JOB #: 52405
6IXTH DEGREE TOWNHOMES
07.14.25

RESPONSE LETTER TO JUNE 6TH PC MEETING:

6IXTH DEGREE TOWNHOMES

SIXTH DEGREE TOWNHOMES

MAIN LEVEL PLAN

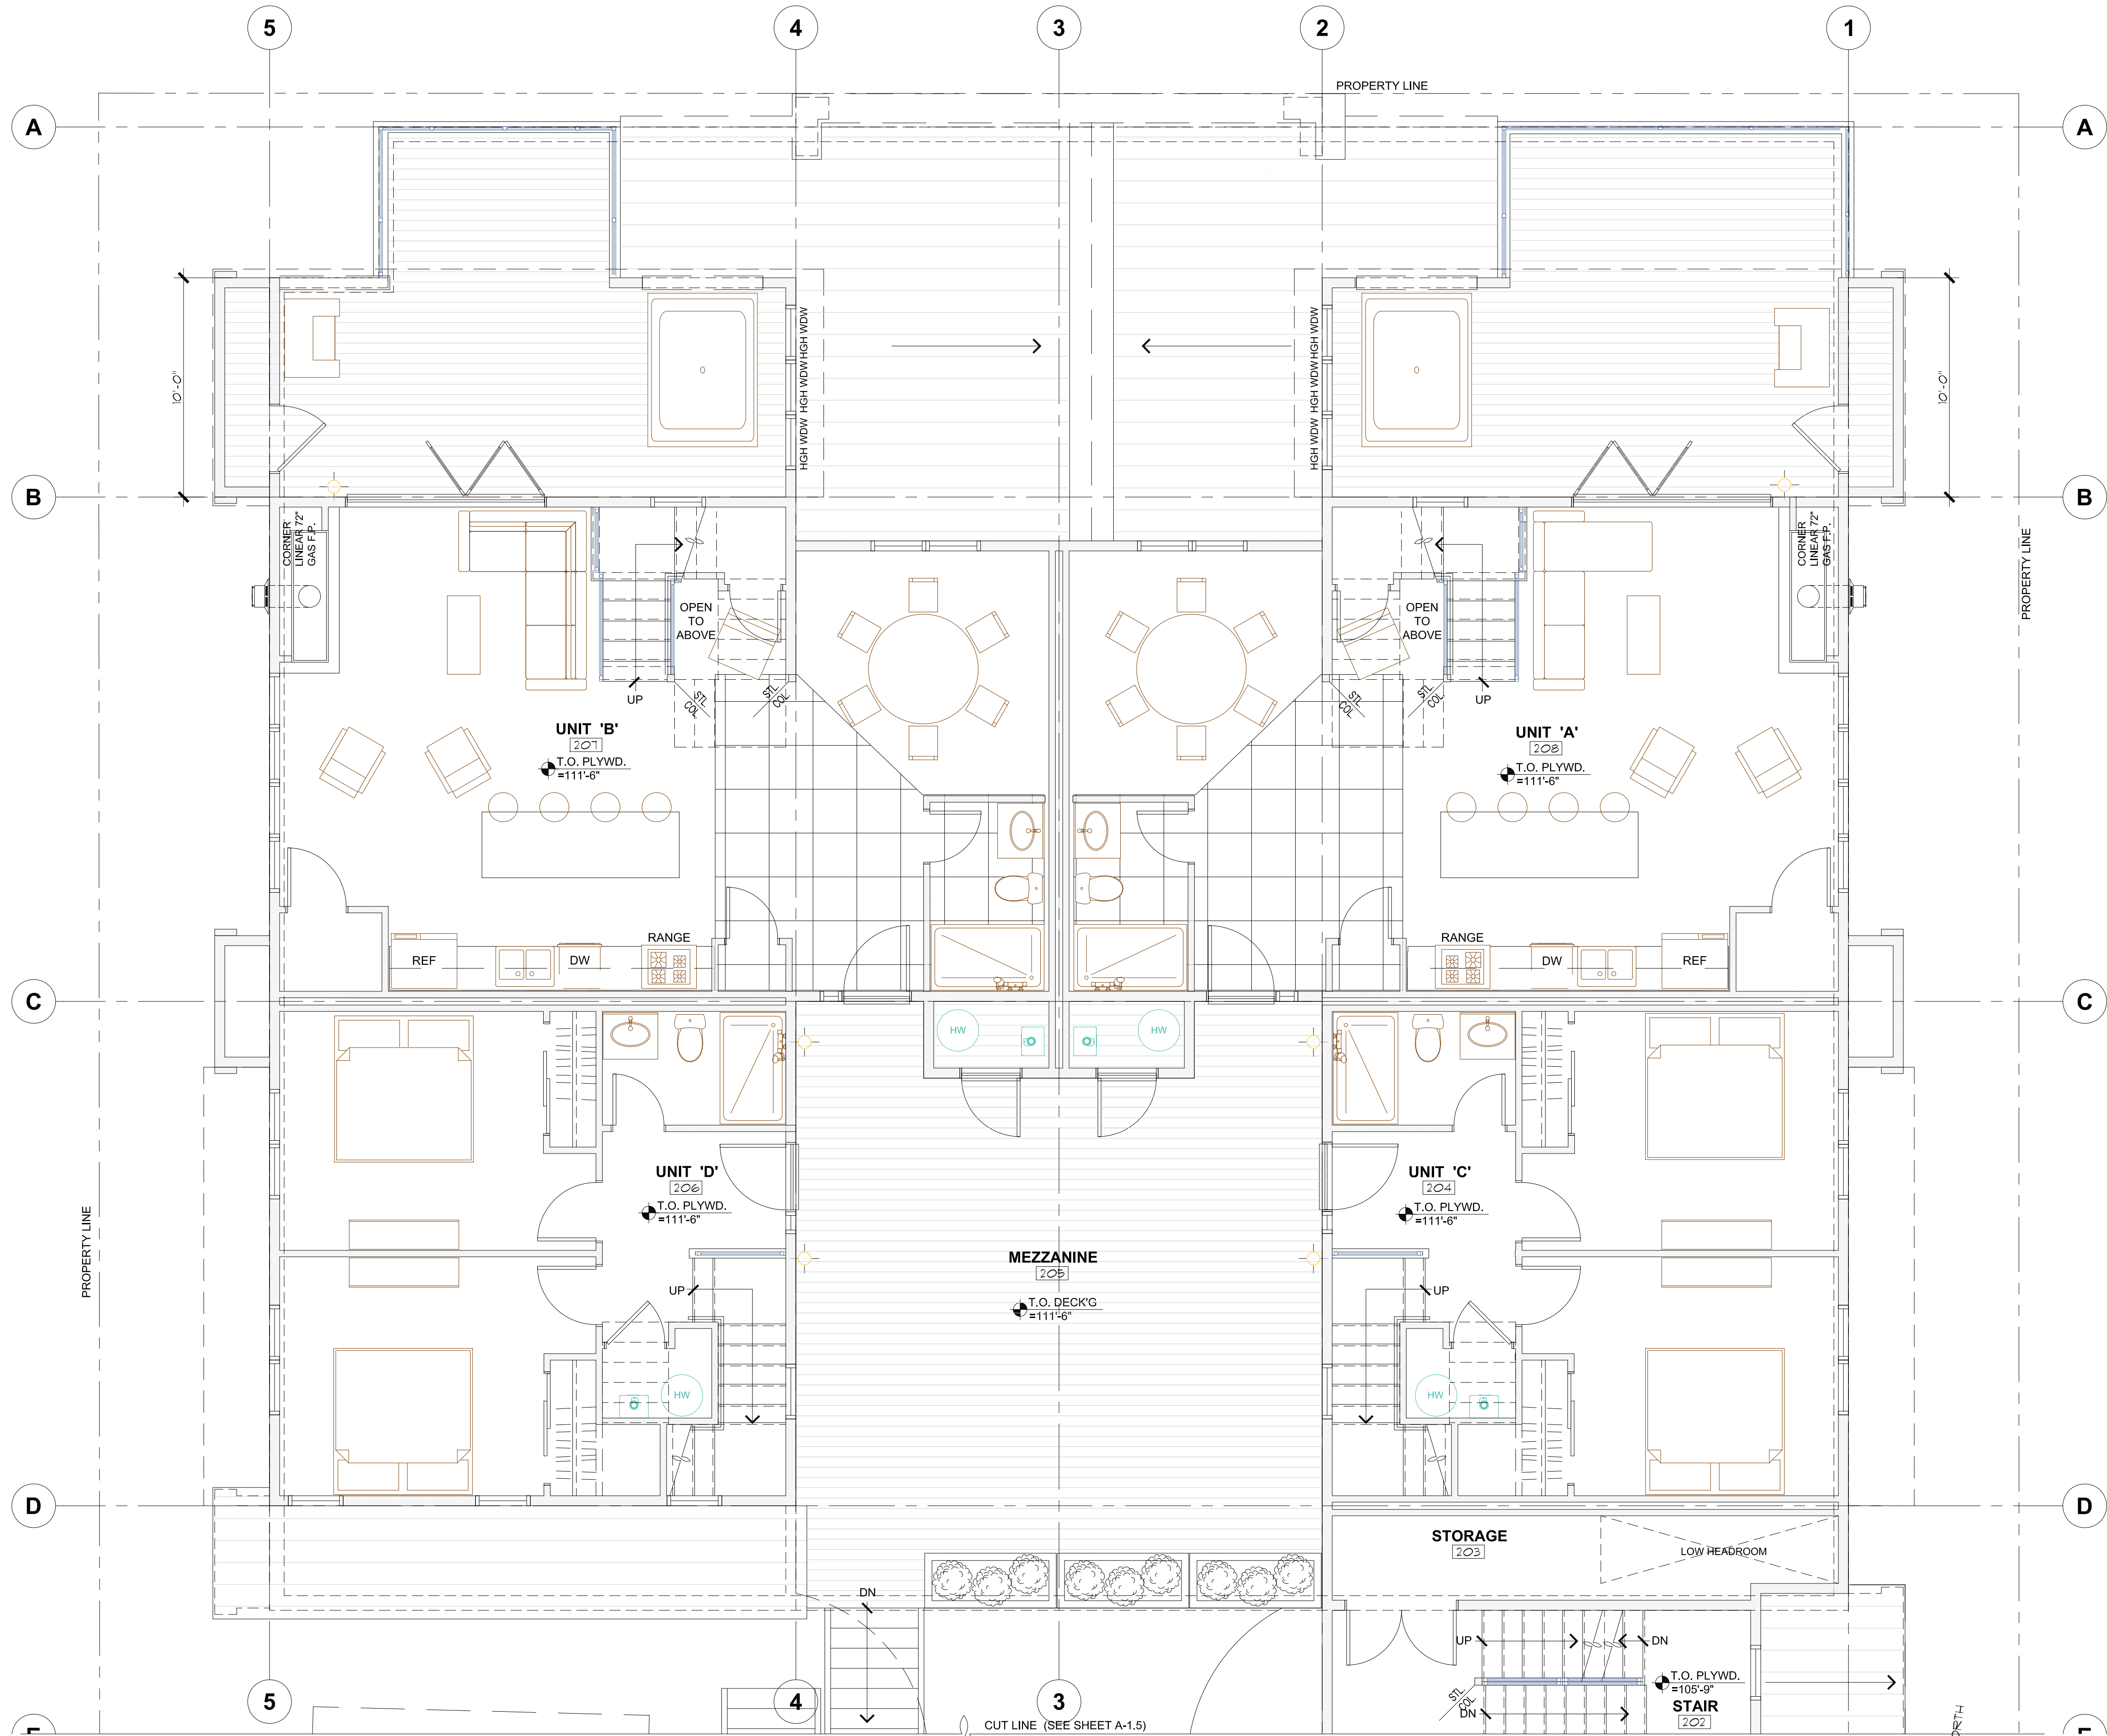
1. Staff does not have enough information to confirm if the structure meets the stepback standards.
- The building has been revised, with 10'-0" setback from the main to the upper level, as dimensioned on the floor plans (A1.5 & A1.6) and illustrated in the building elevations. (A2.1-A2.5)
